BELFORD AVENUE OVER HAPPY CANYON CREEK  
72'30"00" SKEW (TO LAYOUT LINE)  
74'-0" ROADWAY WIDTH, EDGE OF SIDEWALK  
TO EDGE OF SIDEWALK (ULTIMATE)  
8'-6" SIDEWALKS

Print Date: 11/18/2016 8:09:49 AM	Sheet Revisions				As Constructed	BELFORD-HAPPY CANYON CREEK BRIDGE		Project No./Code
File Name: B115360-01INF01.dwg	Date	Comments	Initials		No Revisions:	GENERAL INFORMATION		
Horizontal Scale: VARIES Vertical Scale:				Revised:	Designer: J. LYNCH	Structure Numbers		
				Void:	Detailer: C. MIYAMOTO			
6300 South Syracuse Way, Suite 600 Centennial, CO 80111 tel 303.721.1440 fax 303.721.0832					Subset: BRIDGE	Sheets: B1 of 32		Sheet Number 11

**BELFORD-HAPPY CANYON CREEK BRIDGE**  
**SUMMARY OF QUANTITIES**

**CONSTRUCTION LAYOUT**

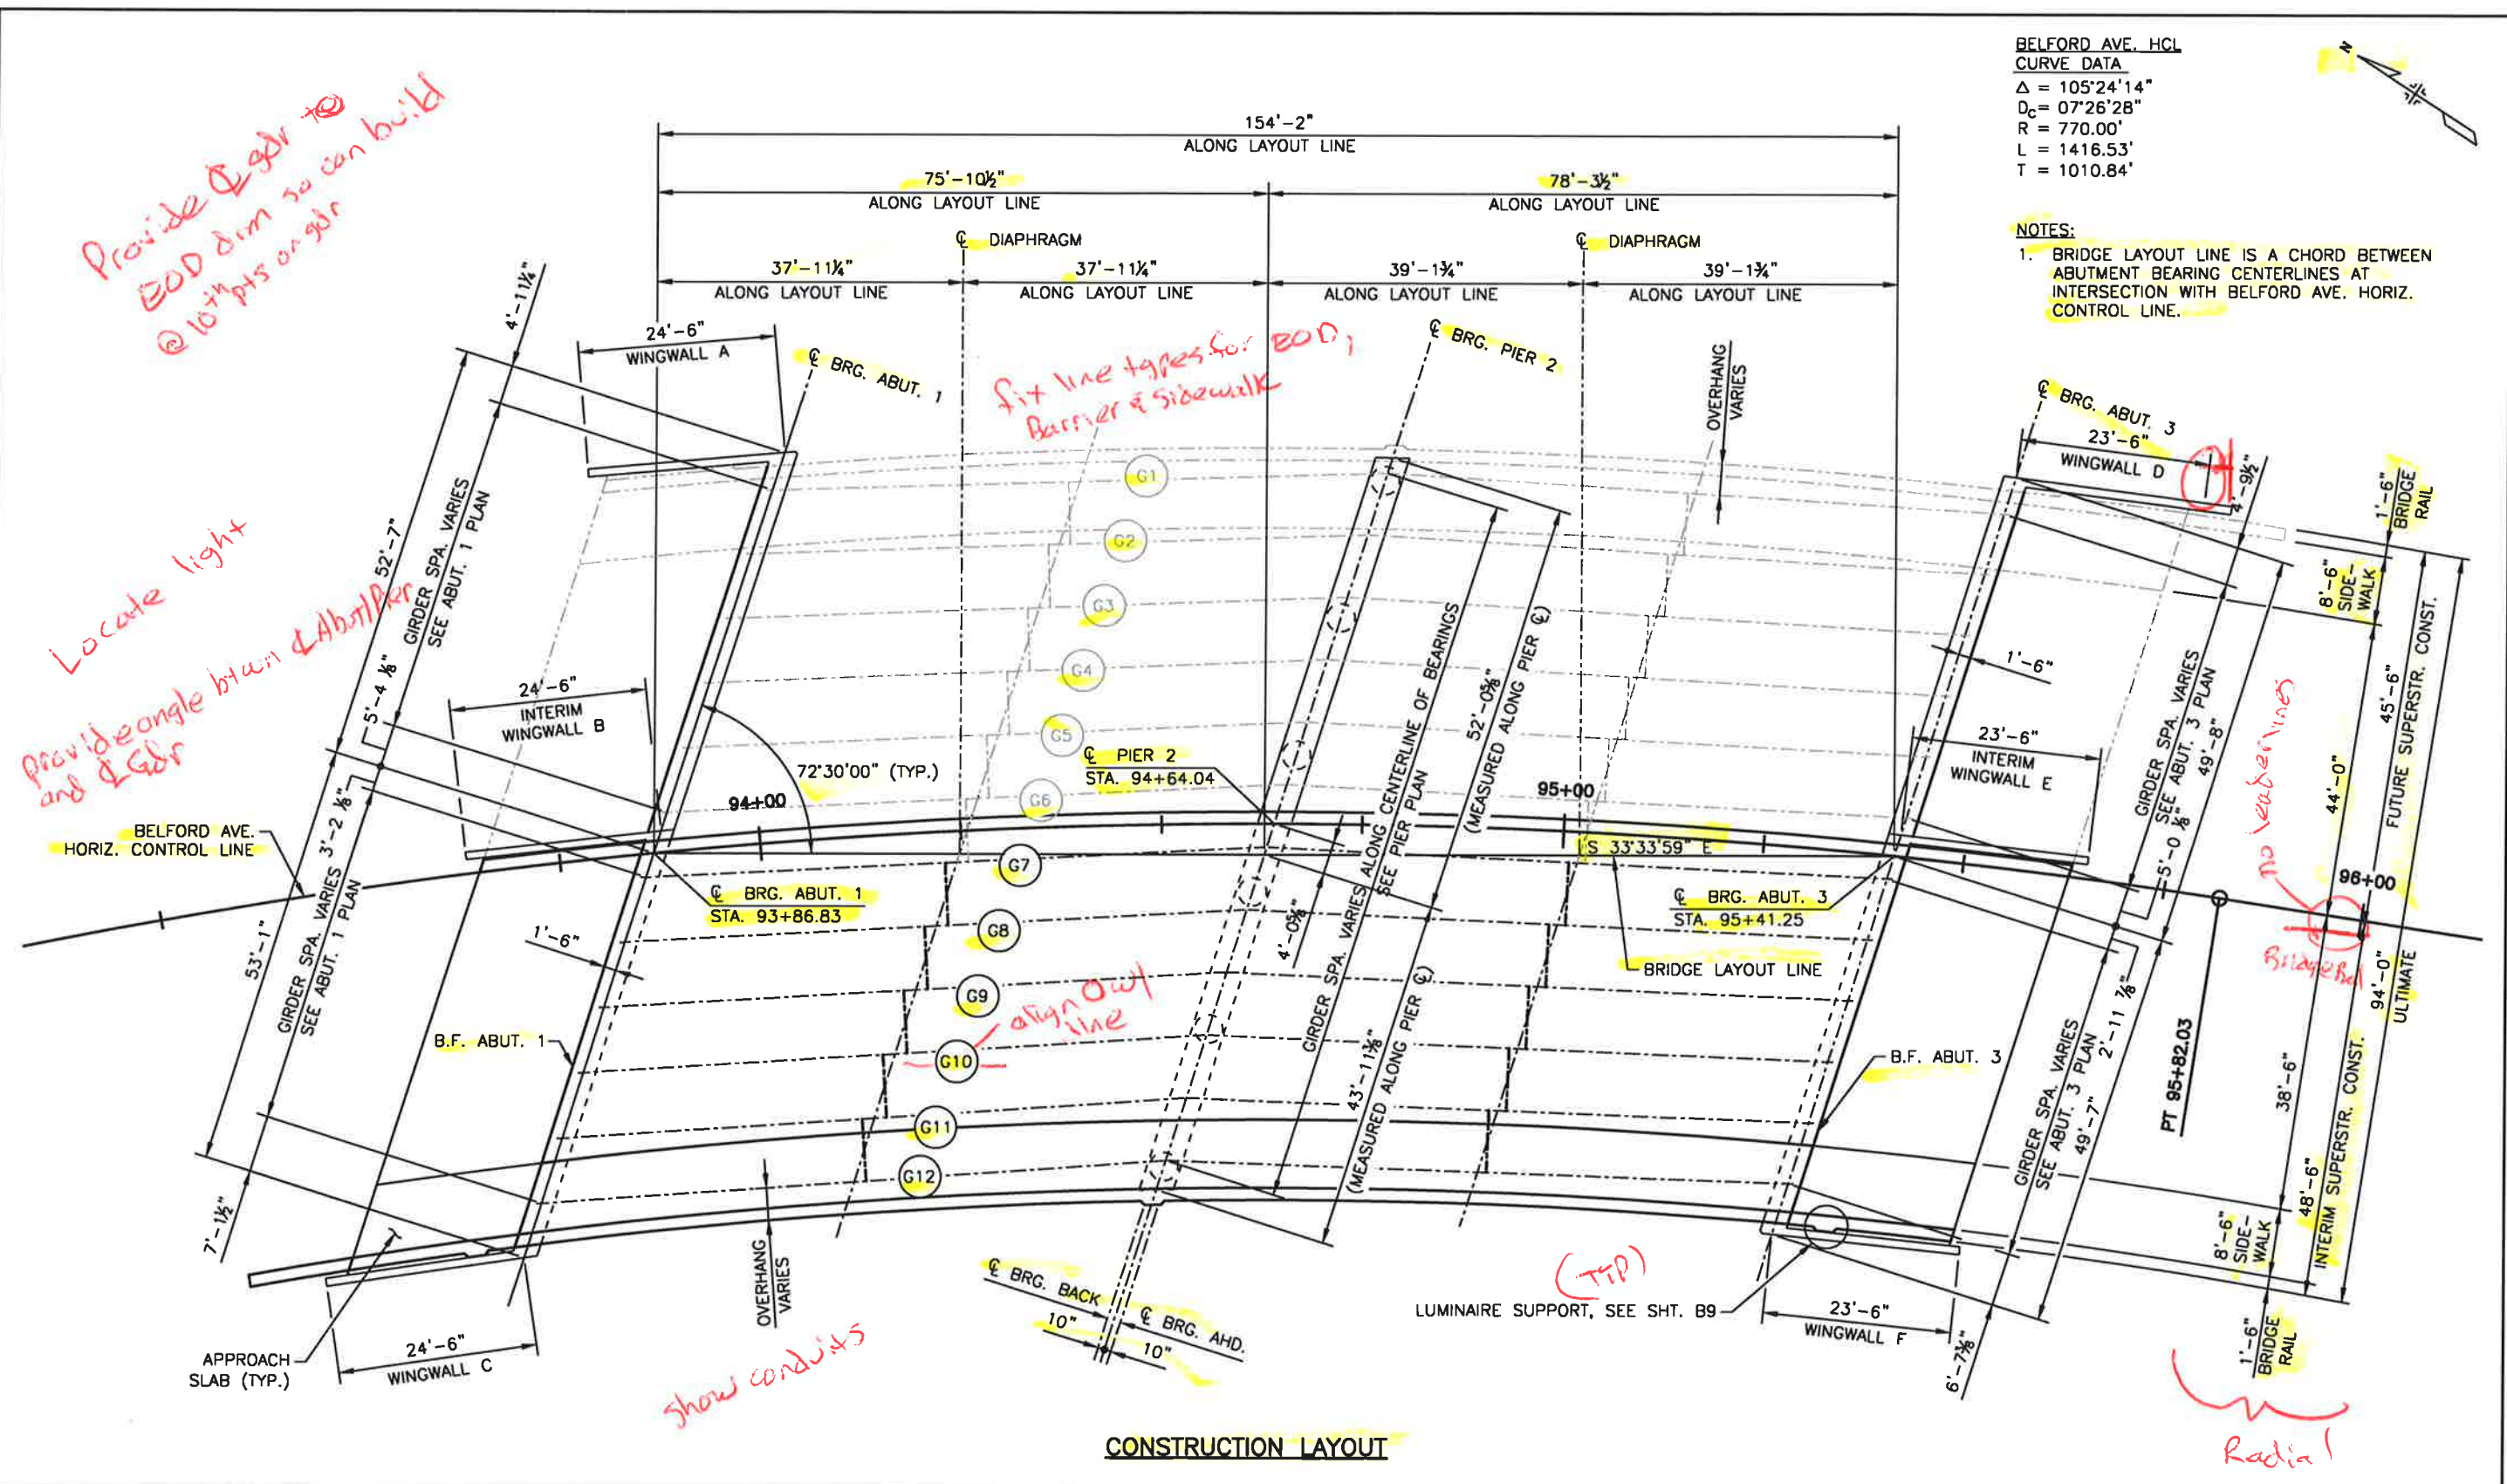
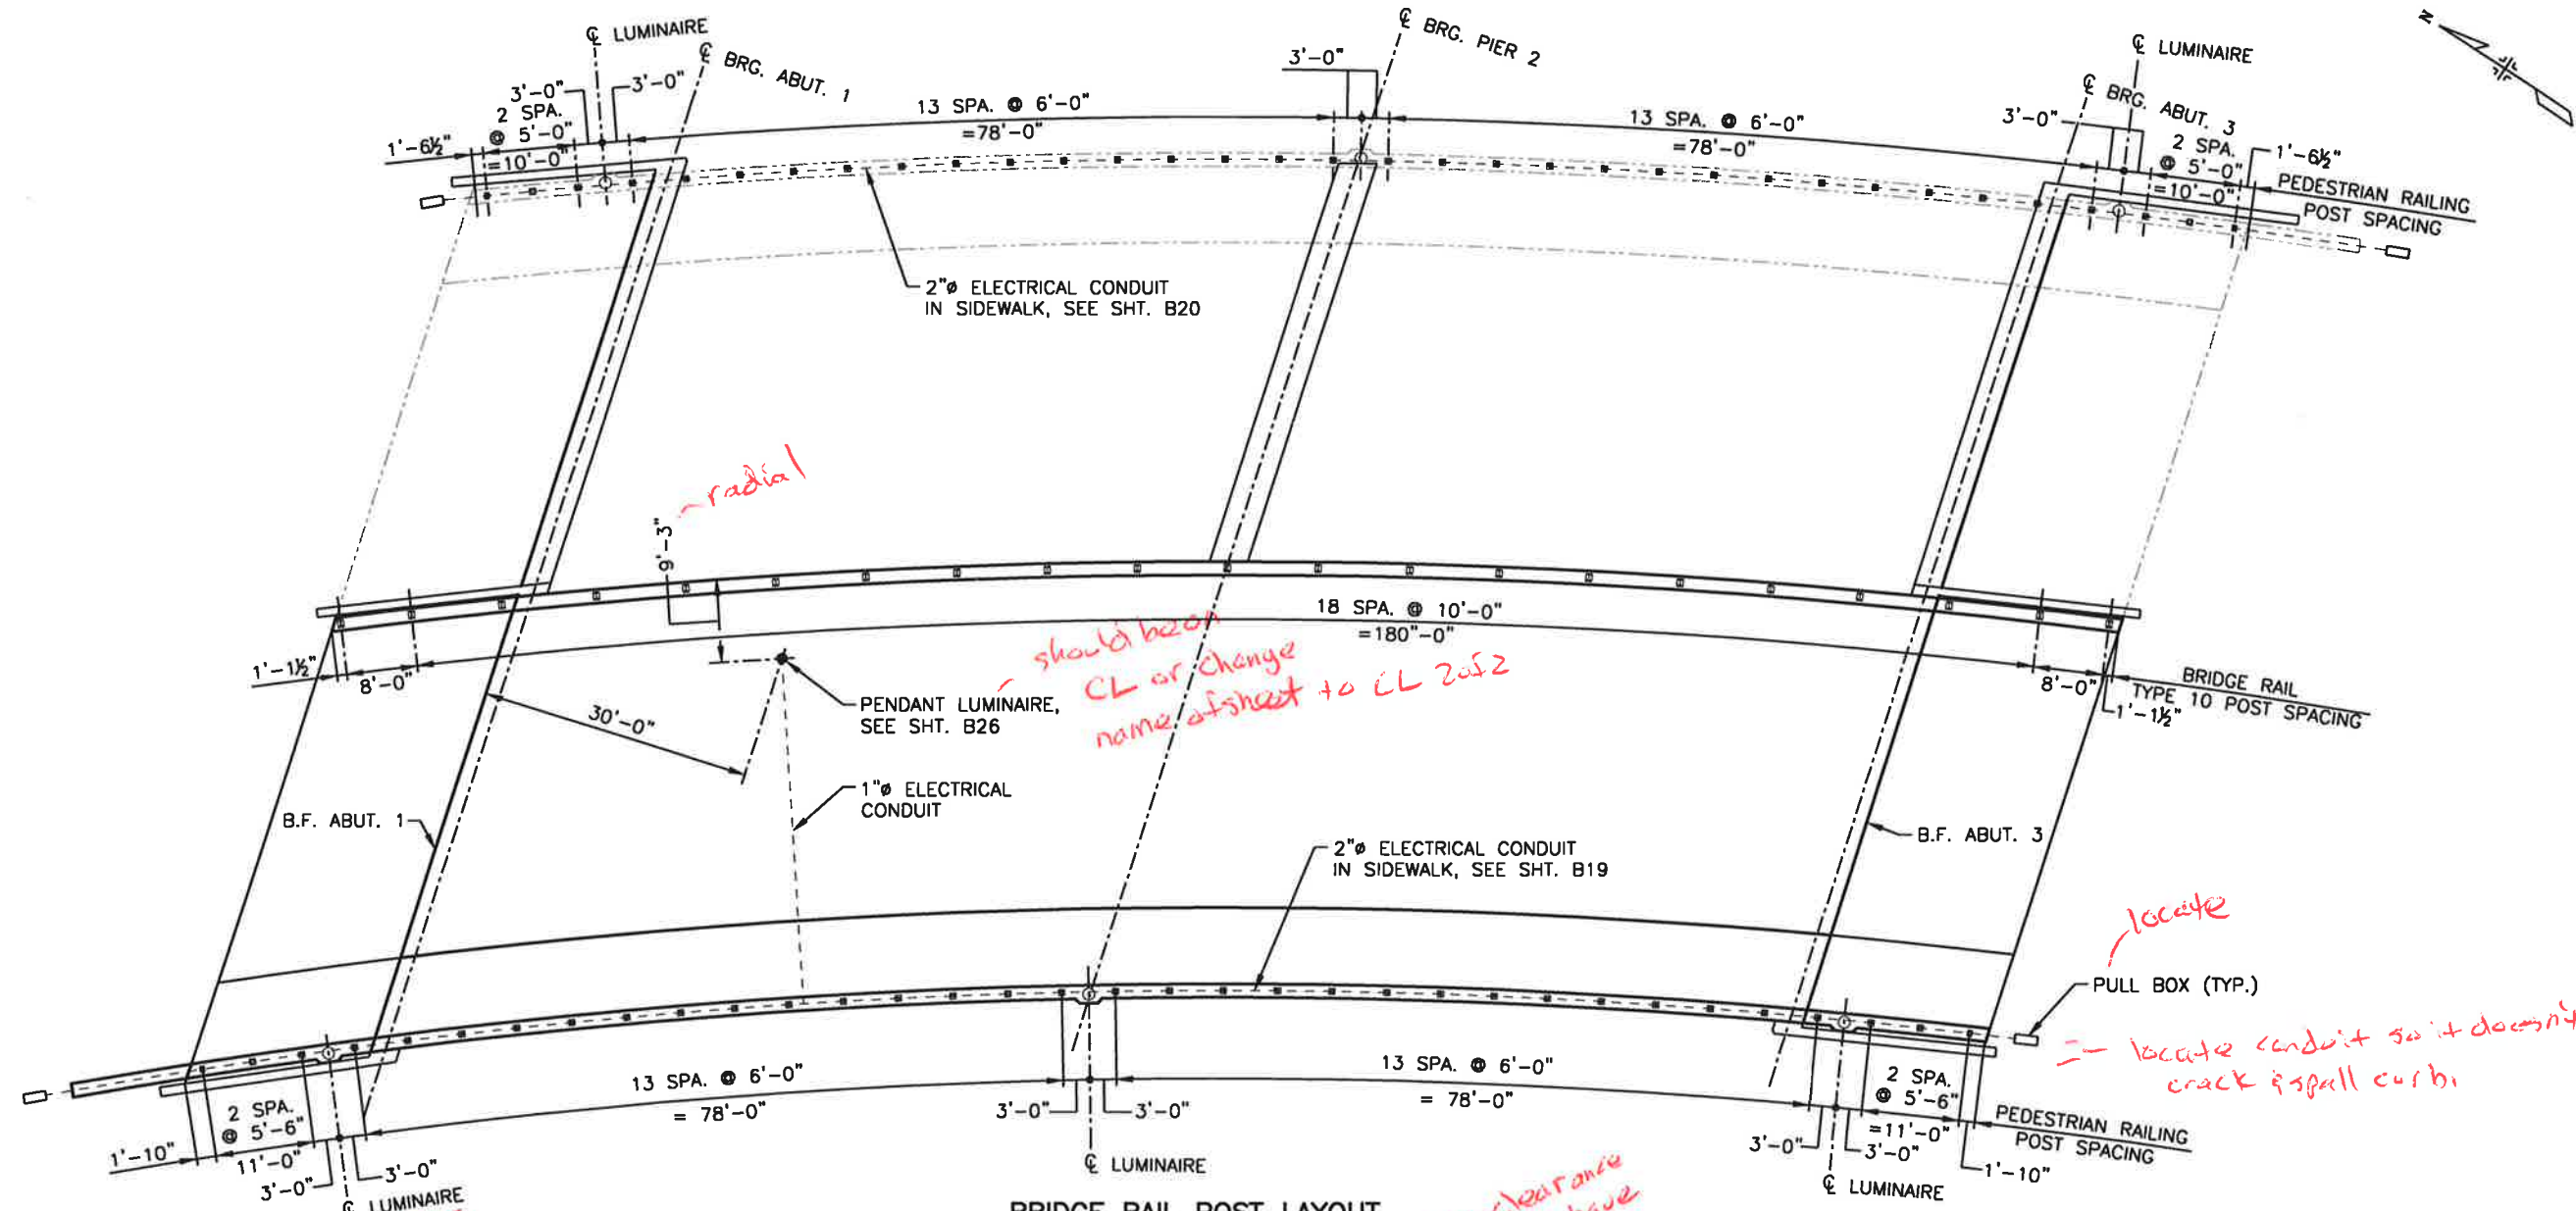
*Provide angle to EOD dim so can build @ 10' pts or gdr*

*Locate light Provide angle btwn abutment and gdr*

*fit line types for EOD, barrier & sidewalk*

*align owl line*

*show conduits*

*no vend lines*

**BRIDGE RAIL POST LAYOUT**

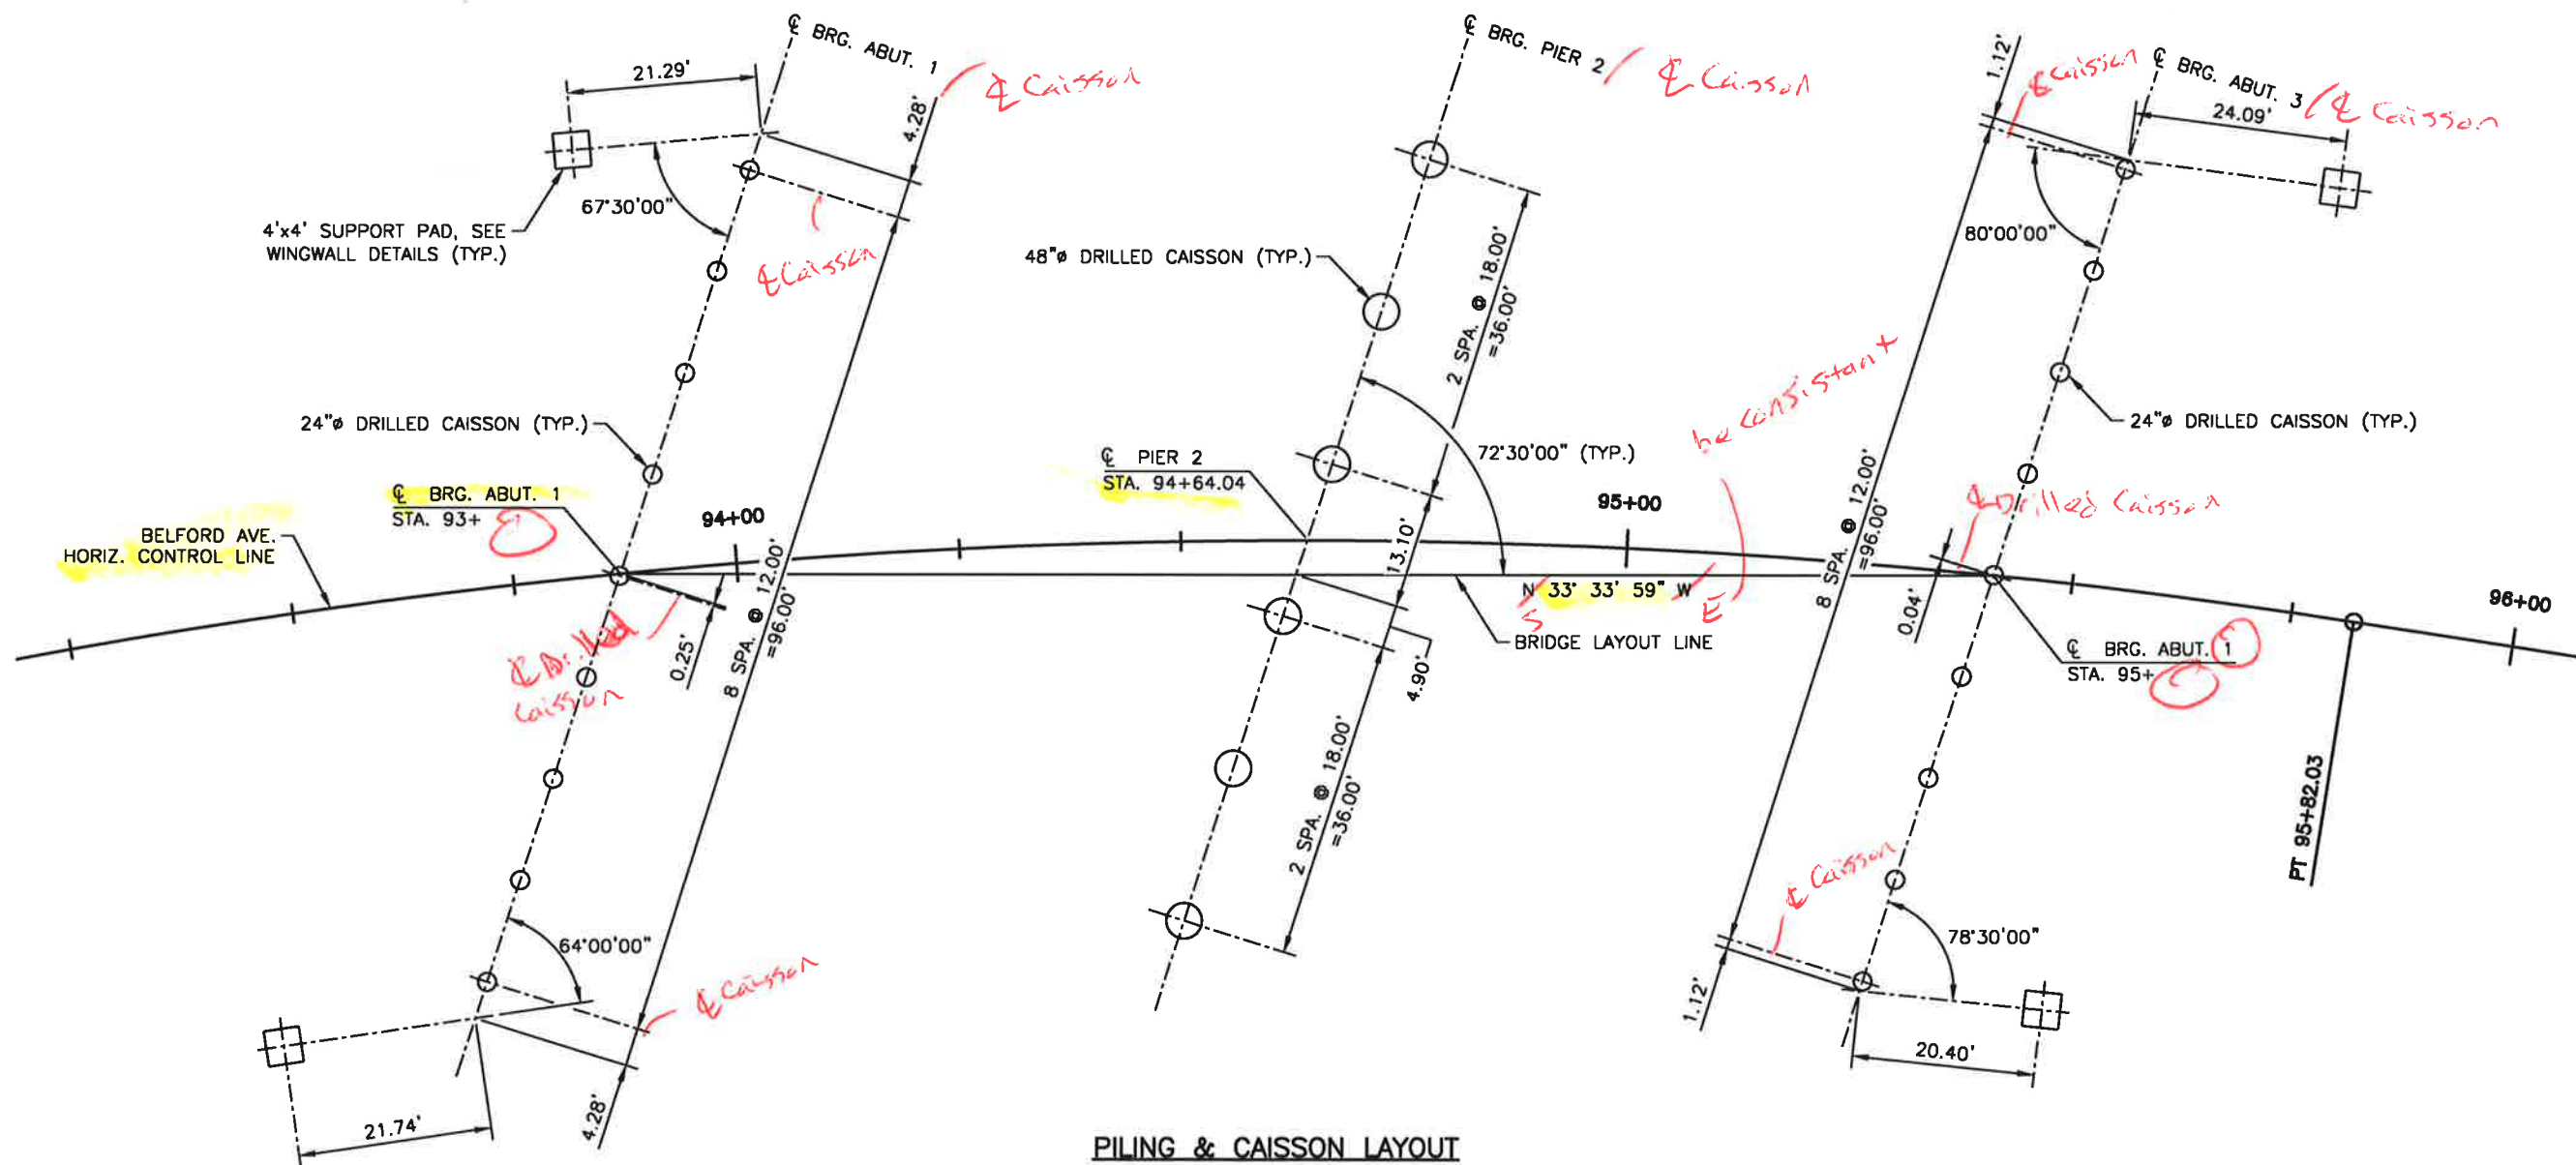
*radial*

*should be on CL or change name of sheet to CL 2 of 2*

*locate*

*locate conduit so it doesn't crack & spill curbs*

*show in elev. don't know where it ends & begins. how does it connect w/ deck barrier stop?*

*no vert. reinf?*

*check bolt pattern clearance to face. Is question you have depth of support to develop the anchor bolts.*
